REQUEST FOR INVITATION TO BID #2026-02
CAMPUS ELECTRICAL DISTRIBUTION
ADDENDUM III
March 4, 2026

1. **Exhibit A – Plans (v.02162026)** shall be amended to include the attached Revised C1.1 – C1.4.

ELECTRICAL PAD PROPOSED SITE PLAN
OREGON INSTITUTE OF TECHNOLOGY
3201 CAMPUS DR.,
KLAMATH FALLS, OREGON 97601

ELECTRICAL PAD DETAILS
OREGON INSTITUTE OF TECHNOLOGY
3201 CAMPUS DR,
KLAMATH FALLS, OREGON 97601

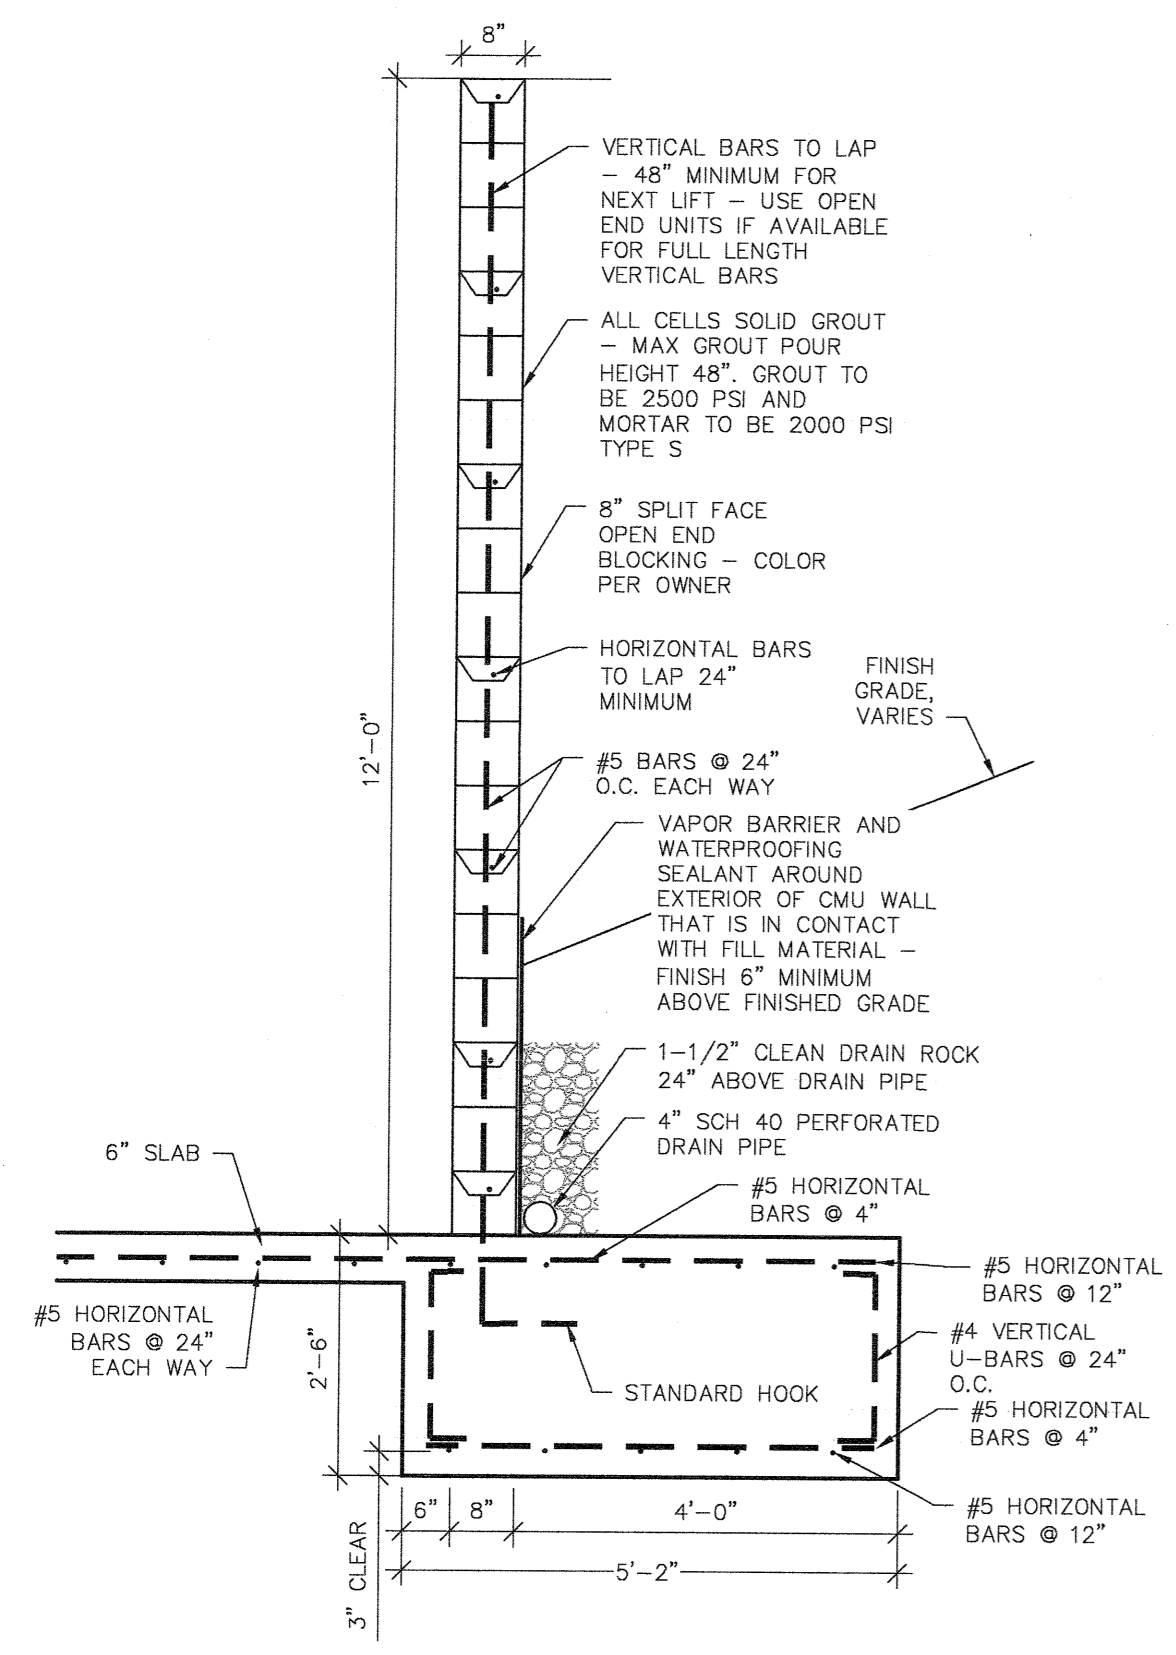
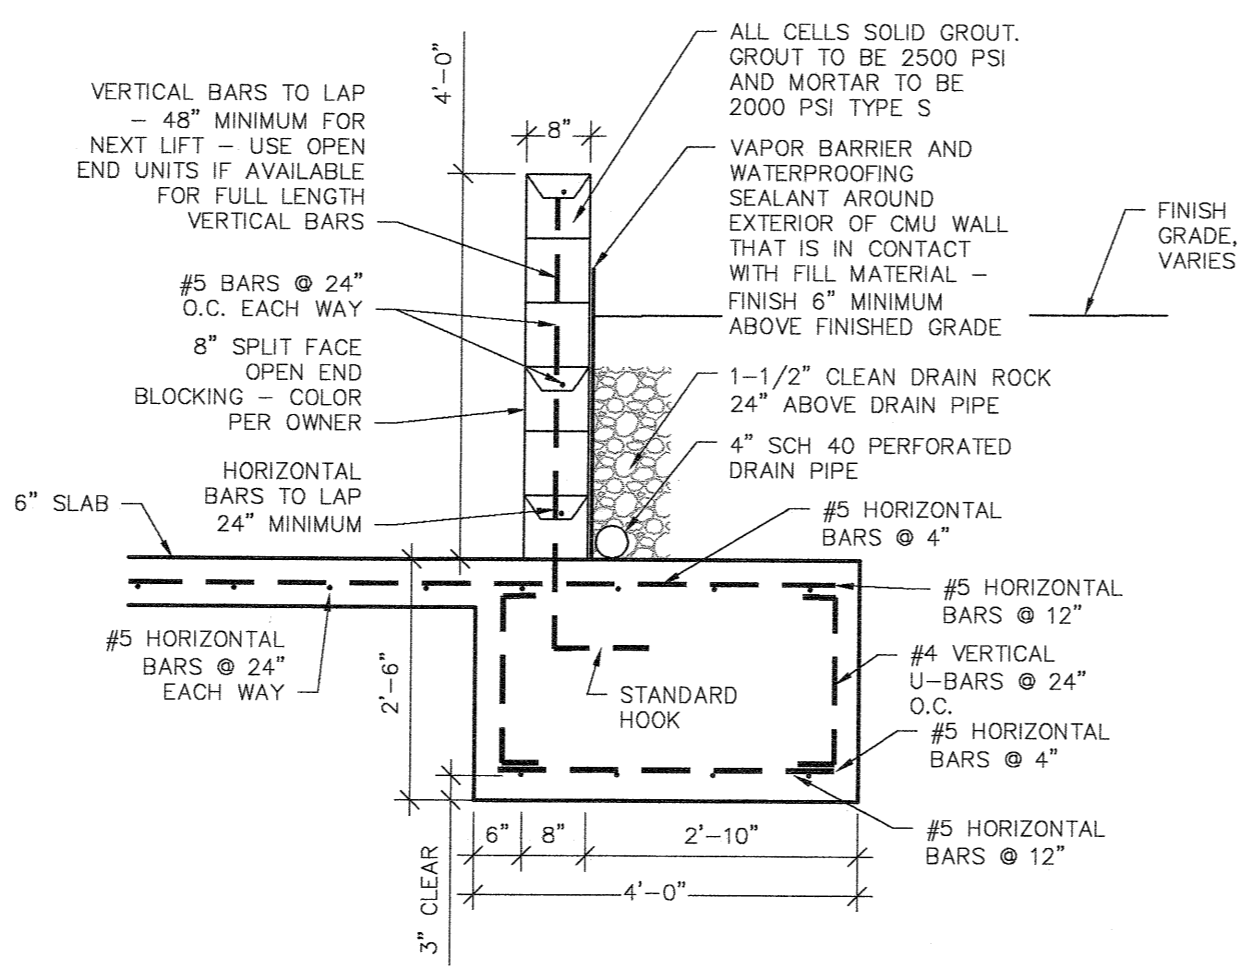
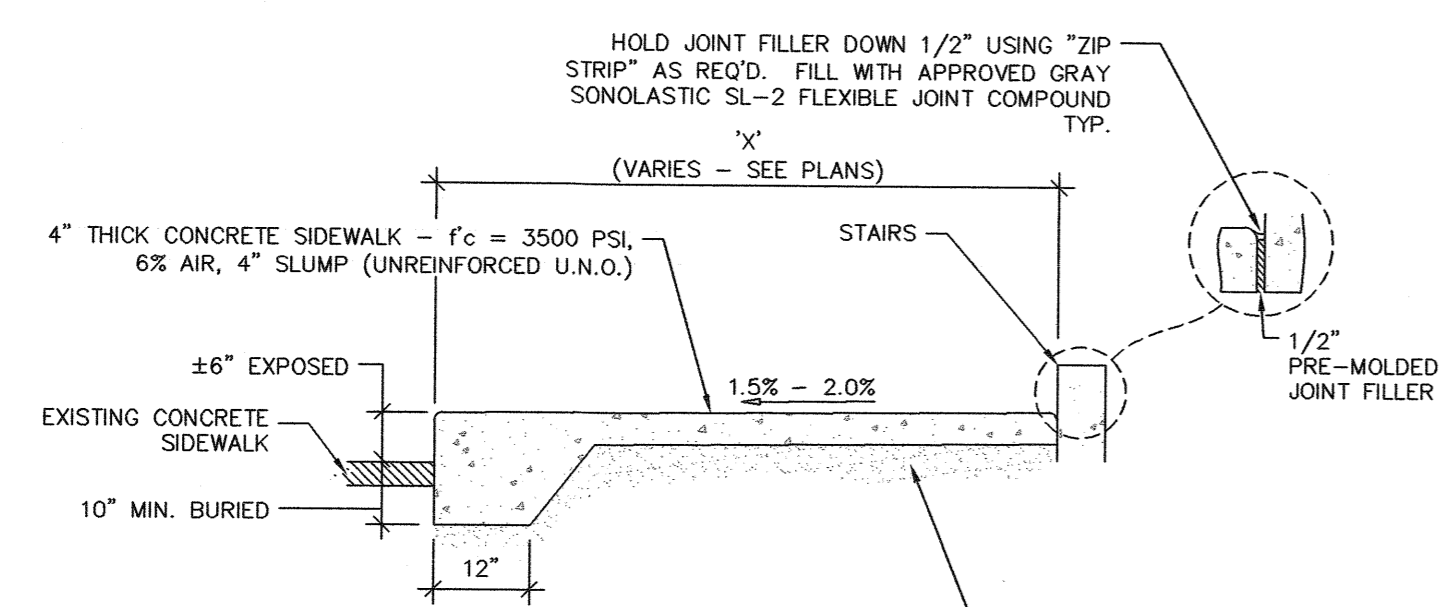
DATE	REVISION DESCRIPTION	BY
3/1/26	LOWER CMU WALL - REMOVE COVER	R.C.
